APPLICATION FOR PERMISSION UNDER SECTION 16 OF THE TOWN PLANNING ORDINANCE (CAP.131)

For Official Use Only 請勿填寫此欄	Application No. 申請編號	A/NE-HLH/51
	Date Received 收到日期	- 2 MAR 2021

(a) Proposed use(s)/development 擬議用途/發展	Proposed Temporary Warehouse and Open Storage of Construction Machinery & Construction Material for a Period of 3 Years (Please illustrate the details of the proposal on a layout plan) (請用平面圖說明擬議詳情)

Application No. 申請編號	(For Official Use Only) (請勿填寫此欄)
Location/address 位置/地址	Lots 171 (Part), 172 (Part), 176 (Part) & 177 (Part) in D.D. 87, Ta Kwu Ling, New Territories
Site area 地盤面積	6,936 sq. m 平方米 <input checked="" type="checkbox"/> About 約 (includes Government land of 包括政府土地 Nil sq. m 平方米 <input type="checkbox"/> About 約)
Plan 圖則	Approved Hung Lung Hang Outline Zoning Plan No. S/NE-HLH/11
Zoning 地帶	'Agriculture' ("AGR")
Type of Application 申請類別	<input checked="" type="checkbox"/> Temporary Use/Development in Rural Areas for a Period of 位於鄉郊地區的臨時用途/發展為期 <input checked="" type="checkbox"/> Year(s) 年 <u>3</u> <input type="checkbox"/> Month(s) 月 _____ <input type="checkbox"/> Renewal of Planning Approval for Temporary Use/Development in Rural Areas for a Period of 位

Proposed Drainage Plan

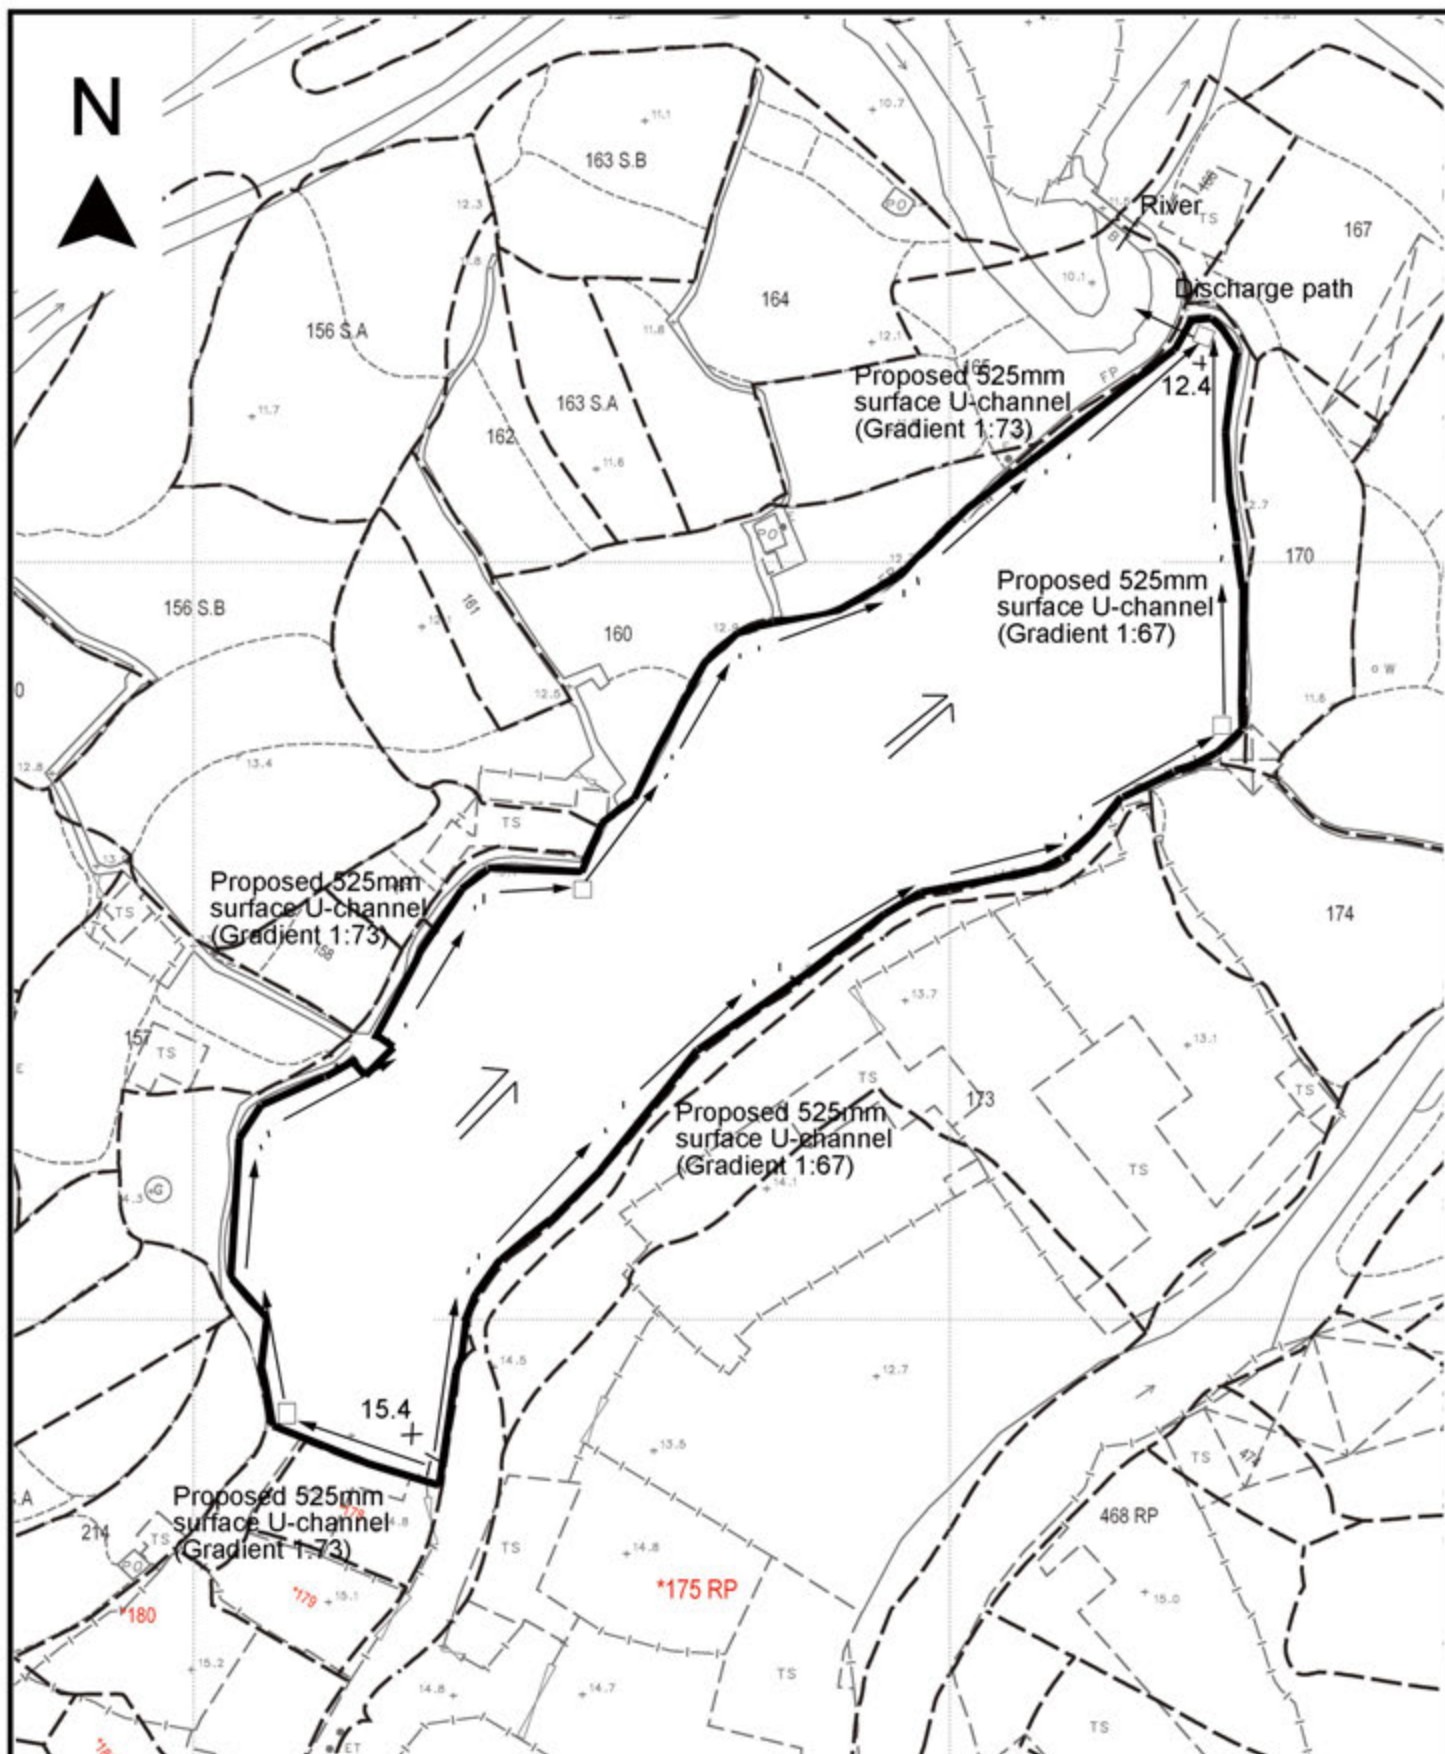
- (ii) a drainage plan should be provided clearly showing the size, levels and routes of the proposed drainage. The details (invert level, gradient, general sections etc.) of the proposed drain/surface channel, catchpits and the discharge structure shall be provided;

- (iii) the cover levels of proposed channels should be flush with the existing adjoining ground level;
 - (iv) a catchpit with covers should be provided where there is a change of direction of the channel/drain. The details of the catchpit with covers shall be provided;

- 1.3.1 Subject to the calculations in 1.2 above, it is determined that proposed 525mm concrete surface U-channel along the site periphery is adequate to intercept storm water passing through and generated at the application site (**Figure 5**).

Proposed Layout Plan

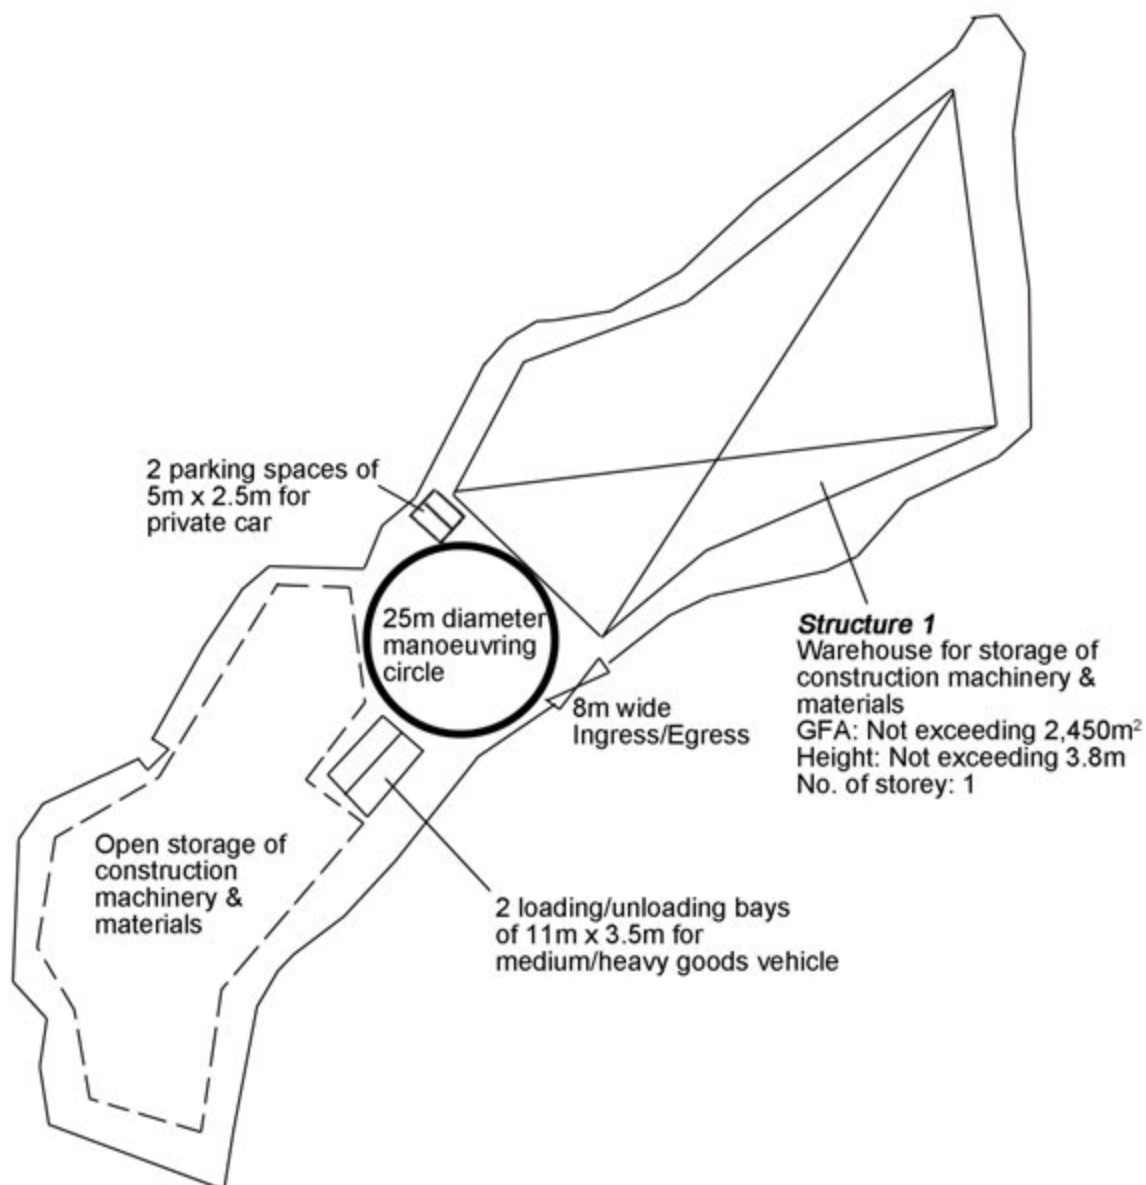
To tally with the information submitted by the traffic consultant, it is proposed that 2 parking space will be reserved for the private car. The location of the parking space reserved for the private car is shown in Figure 3.

Photo of Rockwool Frontrock

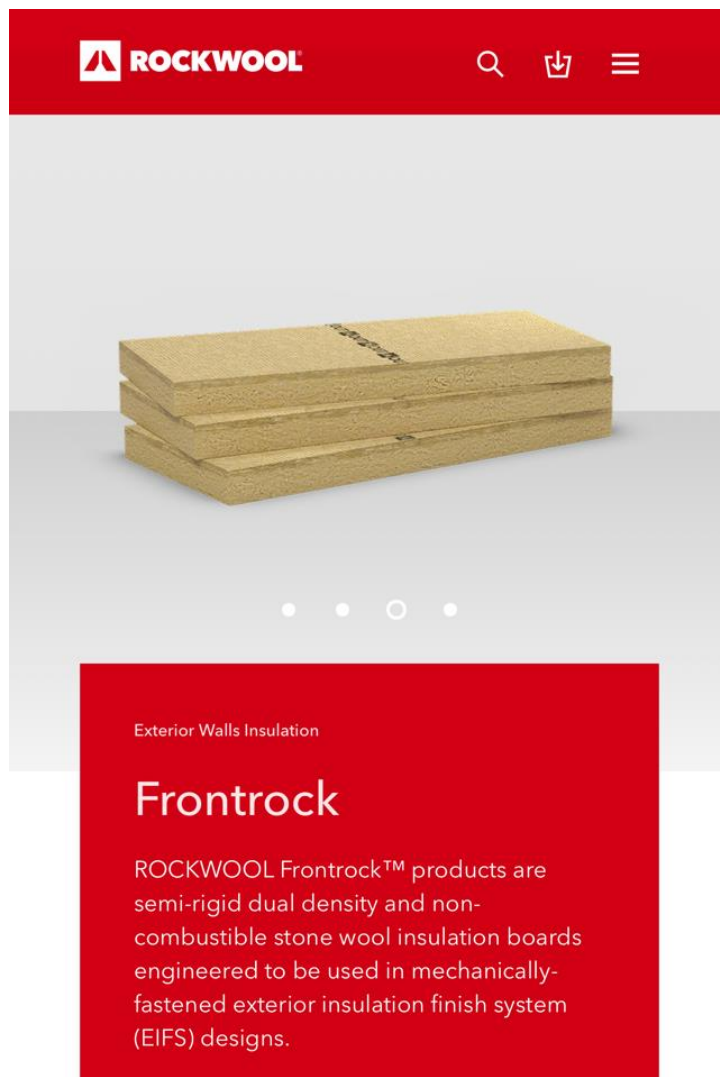
(d) Considering the loading / unloading activities inside the warehouse, the Applicant is advised to state the proposed materials of the warehouse and whether its noise reduction ability is sufficient to avoid noise nuisance / impact on NSRs nearby. To minimise the relevant noise nuisance / impact, the Applicant is advised to provide materials with adequate surface mass density (e.g. > 7 kg/m ²) to minimise noise transmitting through the structure; and	The proposed materials of the warehouse will be soundproofing one such as Rockwool Frontrock (thickness 1.5”) with a density of 136kg/m ³ to minimize noise transmitting through the structure. The picture of Rockwool Frontrock is shown in the attachment.

Figure 1

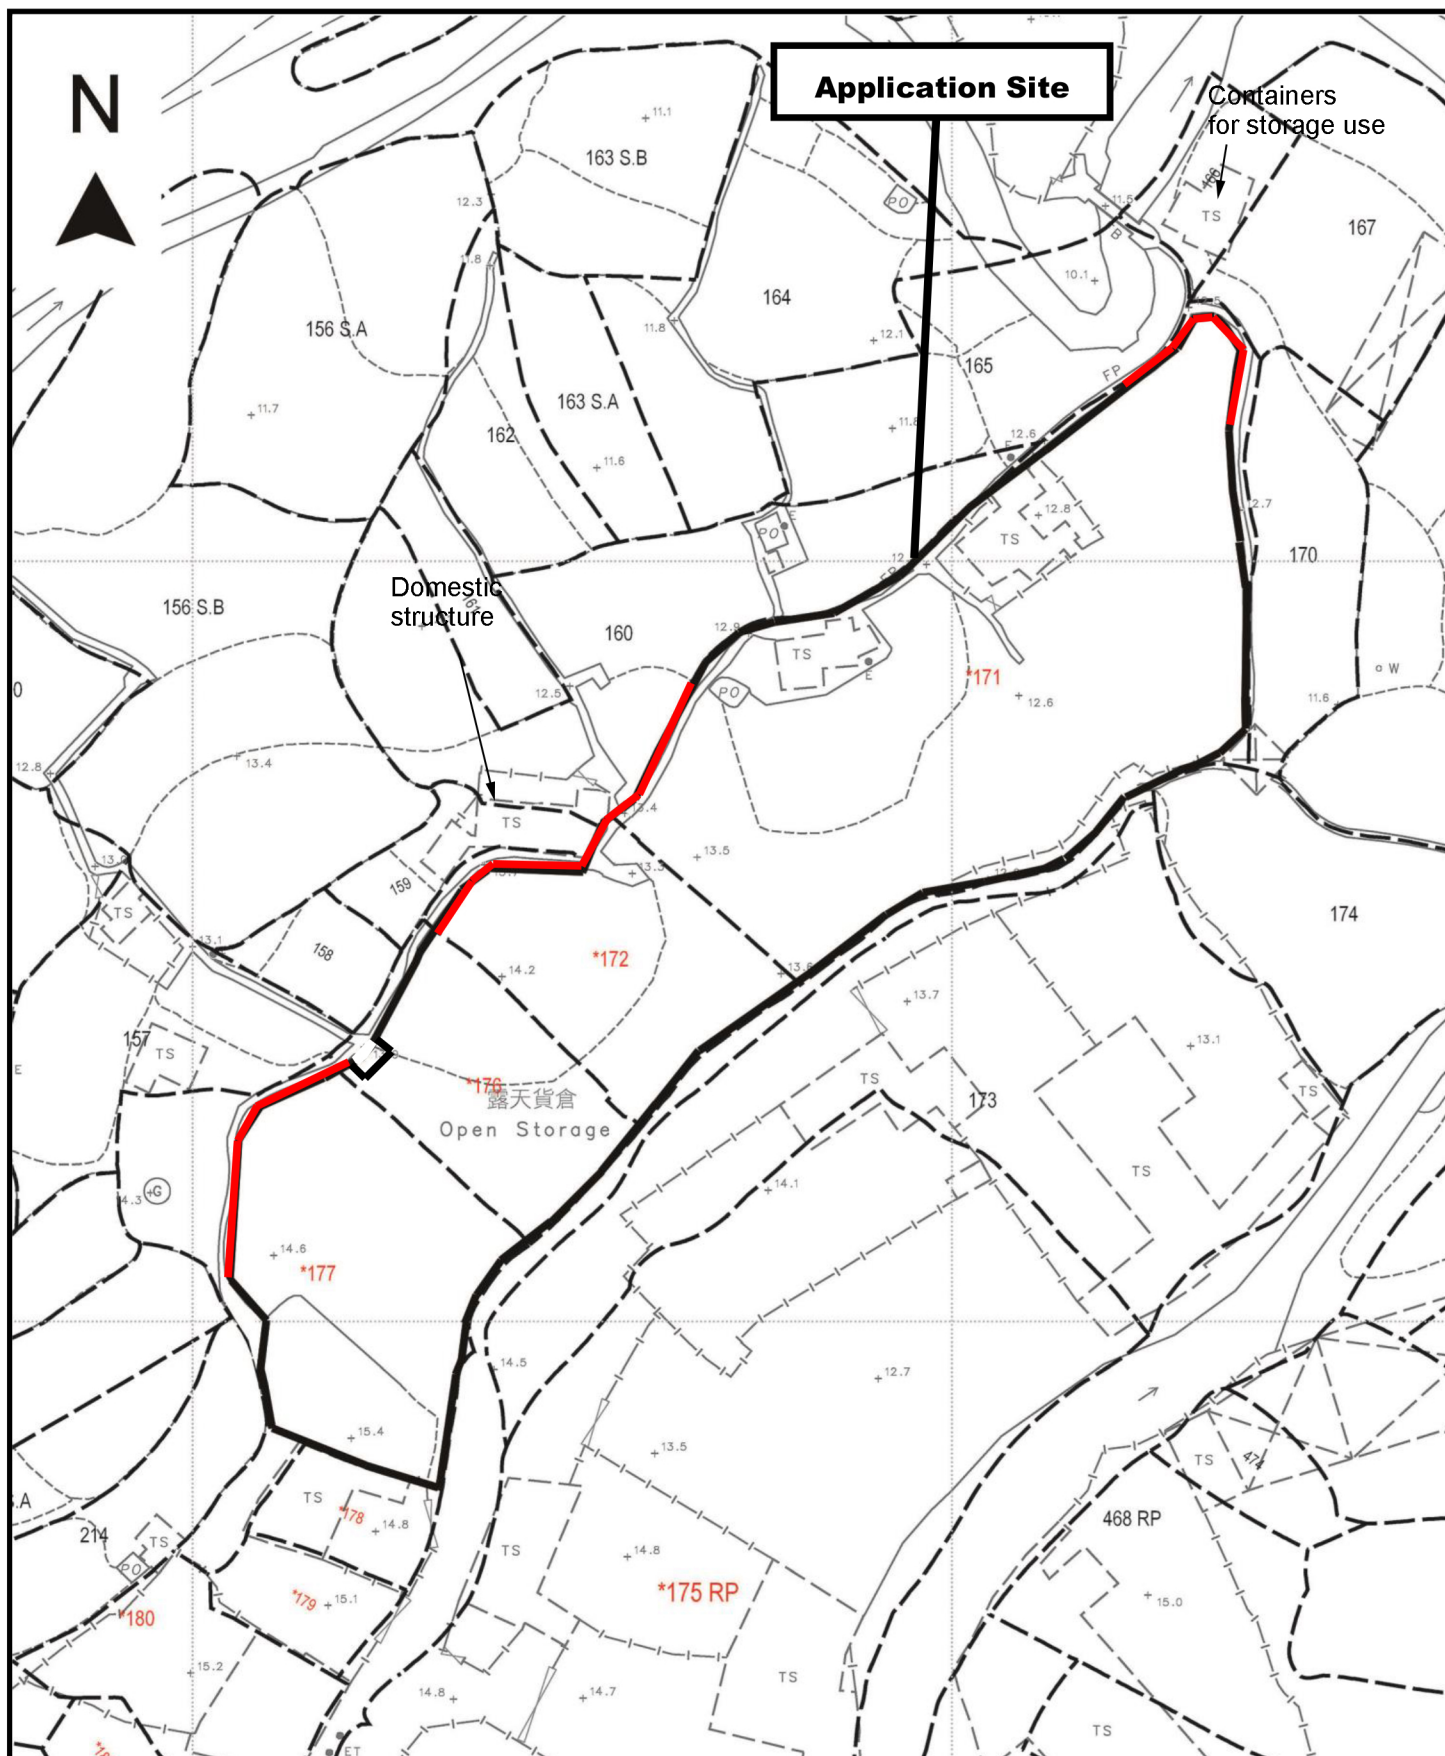
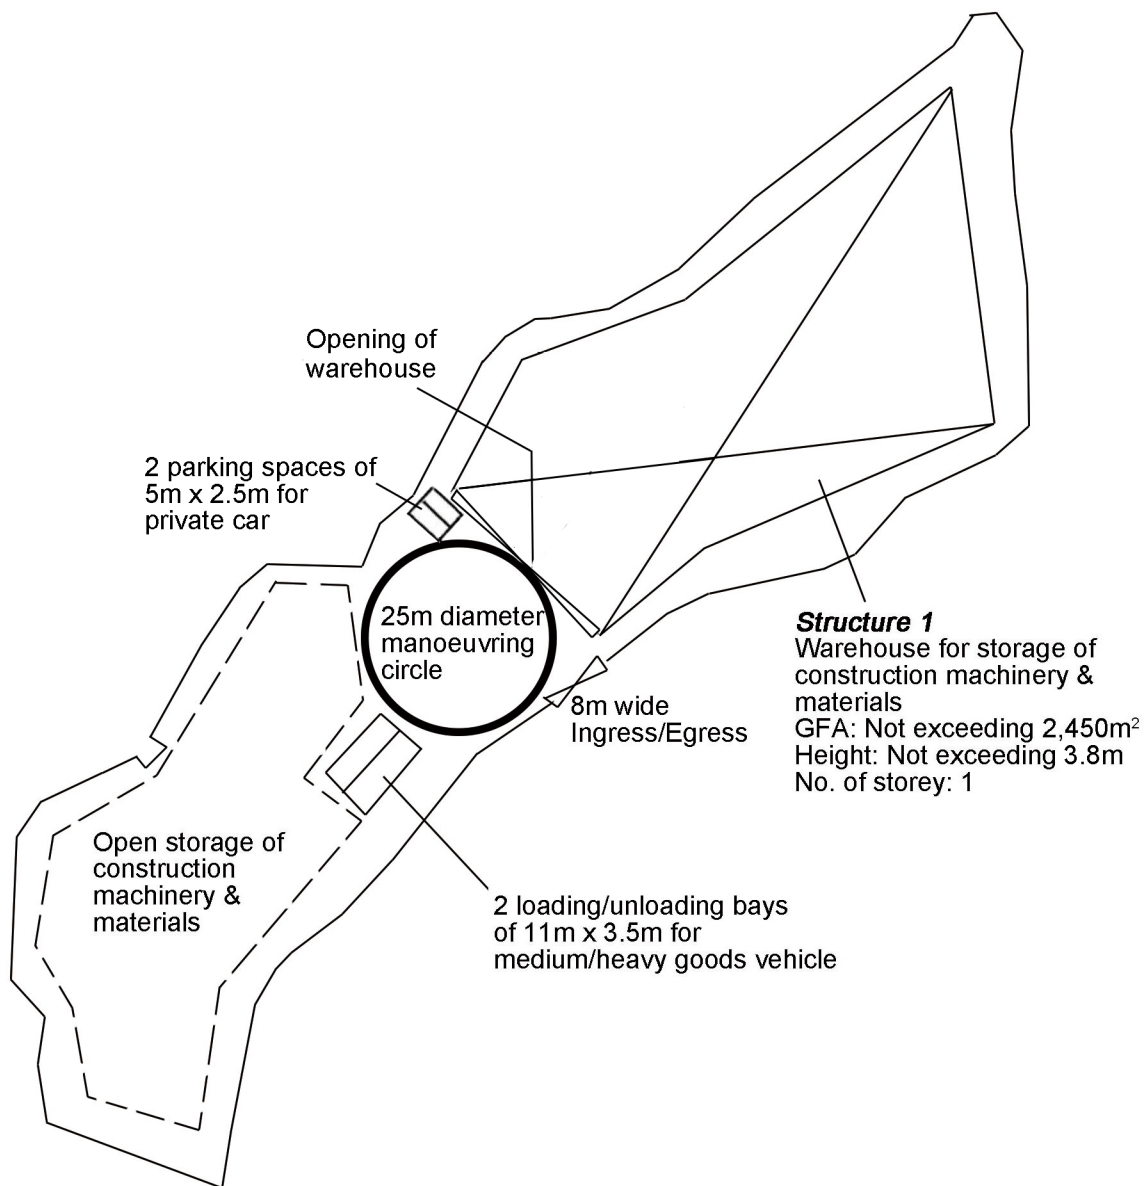
DEP's comments	Applicant's response
(a) The Applicant is advised to review the surrounding environment of the proposed development, including presence of domestic structures, their no. of storeys, and the height of their ventilation openings;	The applicant noted that there are four domestic structures being found to the west, southwest and northeast of the application site as shown in Figure 1A. They are all one storey structure and the windows of the domestic structure is about 1.5m above the ground.

(b) With due consideration of the factors above, the Applicant should review whether the extent and height of the 2.75m high solid boundary walls and the 3.8m high warehouse structure are adequate in screening all on-site activities from the residential buildings in the vicinity. The Applicant is advised to justify whether there is any direct line-of-sight from the residential buildings to the proposed development;	The applicant noted that there are four domestic structures being found to the west, southwest and northeast of the application site as shown in Figure 1A. They are all one storey structure and the windows of the domestic structure is about 1.5m above the ground. As such, the proposed 2.75m high solid boundary walls as shown in Figure 1 (which has been further extended to the southern part of the application site) and 3.8m high warehouse structure are found adequate in screening all on-site activities from the domestic structure to the west of the application site. There is also no direct line-of-sight from the domestic structure

DEP's comments	Applicant's response
(f) Further to our previous comment (a) , the full review of land use in the surrounding environment should cover 100m from the subject site boundary and 50m from the access road to the site. The Applicant should thoroughly review the presence of domestic structures nearby, their no. of storeys, and the extent of their ventilation openings, preferably based on site survey results of structures nearby and supported with photos. This includes but not limited to the residential buildings adjoining the site at the northern boundary, about 83m to the southwest of the site, and about 50-70m away from the northeastern boundary of the site, as stated in our previous reply;	Noted. Four domestic structures were found within 100m from the subject site boundary and 50m from the access road. All the domestic structures are 1 storey and the ventilation openings is only about 1.5m above the ground surface. Please see photos in the attachment.

The applicant noted that there is one domestic structure to the west of the application site as shown in Figure 1. It is a one storey structure and the windows of the domestic structure is about 1.5m above the ground. As such, the proposed 2.75m high solid boundary walls as shown in Figure 1 and 3.8m high warehouse structure are found adequate in screening all on-site activities from the domestic structure to the west of the application site. There is also no direct line-of-sight from the domestic structure to the proposed development.

Photo for domestic structure at Lot 157 in D.D.87 (Photo 1 in Figure 1)

Photo for domestic structure at Lot 159 in D.D.87 (Photo 2 in Figure 1)

Photo for domestic structure at Lot 183 S.A in D.D.87 (Photo 3 & 4 in Figure 1)

Photo for domestic structure at Lot 491 S.A in D.D.87 (Photo 5 & 6 in Figure 1)
